Product Change Notification: SYST-07SVSW972

11-Jun-2026

MCP19214/15 Silicon Errata and Data Sheet Clarification

Figure 2-1. Schematic 1

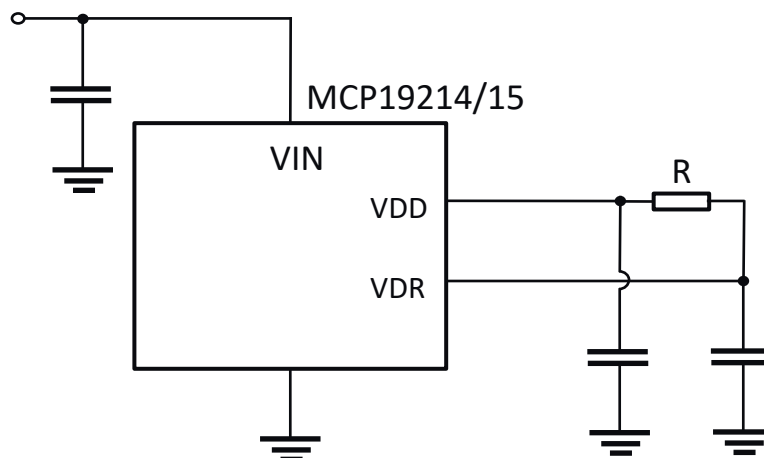
If power is applied to VDR before VDD has reached the minimum operating voltage a pulse of VDR voltage will appear on PDRV1 and PDRV2.

The pulse width can be sufficiently long to cause power switch turn ON and power train damage.

If VIN is powered down or VDD goes low, and VDR is present, while PDRV1/PDRV2 is High or while being High during a switching cycle, then PDRV1/PDRV2 might remain stuck High.

This can cause power switch to be stuck ON and the power train to be damaged.

Power up sequencing enabled by VDD is recommended to be used for VDR supply.

VDR must not be powered if VDD has not reached minimum operating voltage.

A recommended implementation for correct power up sequencing can be found in [Schematic 1](#).

Resistor R is recommended to be below 3.3 Ω to make sure the voltage drop during switching does not cause driver undervoltage events. Further optimizations can be done based on the value of the selected decoupling capacitor.

A recommended implementation for correct power DOWN sequencing can be found in [Schematic 1](#).

If VIN gets LOW, diode D must be selected to have enough current capability to discharge the VDR filter capacitors before VDD capacitors are discharged
